**PLANNED UNIT DEVELOPMENT
& SUBDIVISION STAFF REPORT****Date: March 7, 2013****DEVELOPMENT NAME**

Westwood Plaza Subdivision

Planned Unit Development Approval to allow multiple buildings on a single building site, with shared access between multiple building sites, and Subdivision approval to create 5 lots.

SITE PLAN

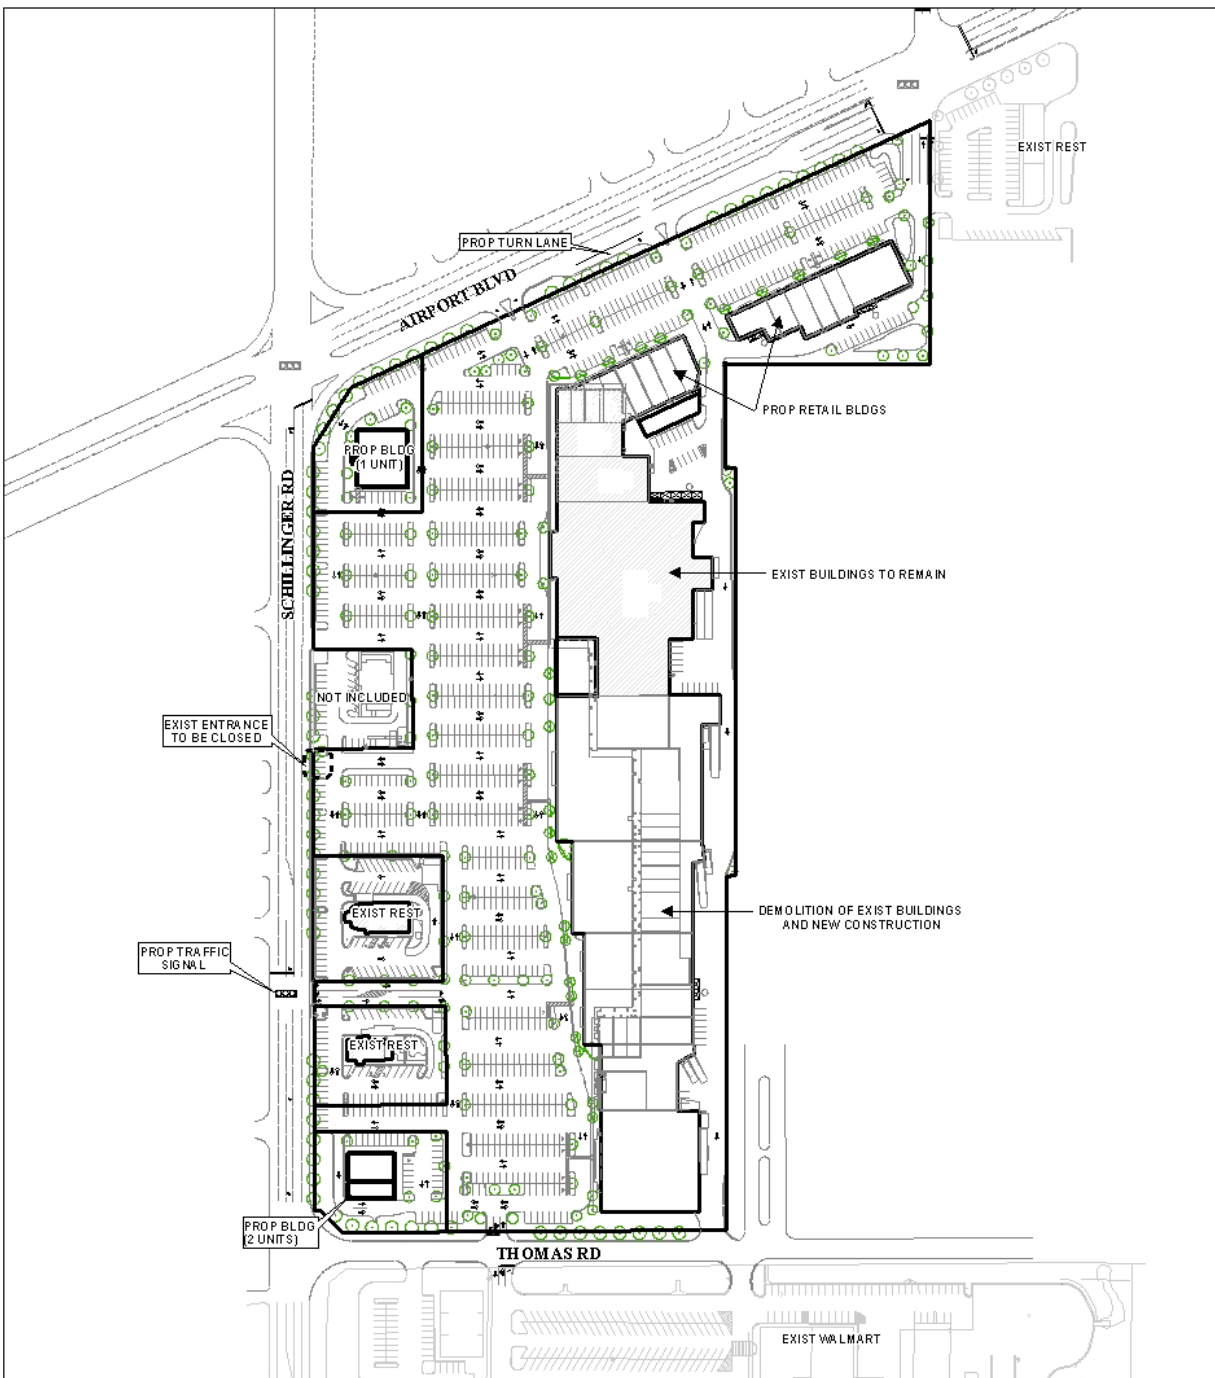
Regarding trees, 89 frontage trees, 82 perimeter trees and 59 parking area trees will be required, for a total of 230 trees to be provided on site. The site plan only depicts 219 trees (those on the Wendy's site are excluded since they are not part of the PUD application). It should also be pointed out that the site plan indicates that many of the proposed frontage trees will be in the right-of-way along all three fronting roads. The site plan should be revised to depict all required trees on the site.

The site abuts an R-3, Multi-Family Residential District property that is developed with apartments. The Zoning Ordinance requires that the commercial site provide a 10-foot wide setback buffer, and either an evergreen vegetative buffer or a six-foot high wooden privacy fence. The site plan should be revised to depict the buffer required by Section 64-4.D.1. of the Zoning Ordinance.

A Sidewalk Waiver application was not included for consideration with the two applications at hand. Therefore, the site plan should be revised to depict a sidewalk along all street frontages, or a note should be placed on the site plan indicating that a Sidewalk Waiver will be requested.

The 25-foot minimum building setback line is not depicted on the preliminary plat or the site plan. Both the plat and the site plan should be revised to depict the minimum building setback line, adjusted for any requested or future right-of-way dedication.

- 2) Revision of the site plan to reflect right-of-way dedication along Schillinger Road, as specified for the Subdivision plat;
- 3) Revision of the site plan to reflect the required 25-foot minimum building setback line along all street frontages, adjusted for required dedication or additional setback;

- 4) Revision of the site plan to depict sidewalks along all street frontages, or placement of a note on the site plan stating that a Sidewalk Waiver application will be submitted;

- 9) Revision of the site plan to depict full compliance with the tree and landscape requirements of the Zoning Ordinance, or provision of justification as to why the development will not meet the minimum requirements; and
- 10) Revision of the site plan to depict a 10-foot wide setback buffer, and either an evergreen vegetative buffer or a six-foot high wooden privacy fence.
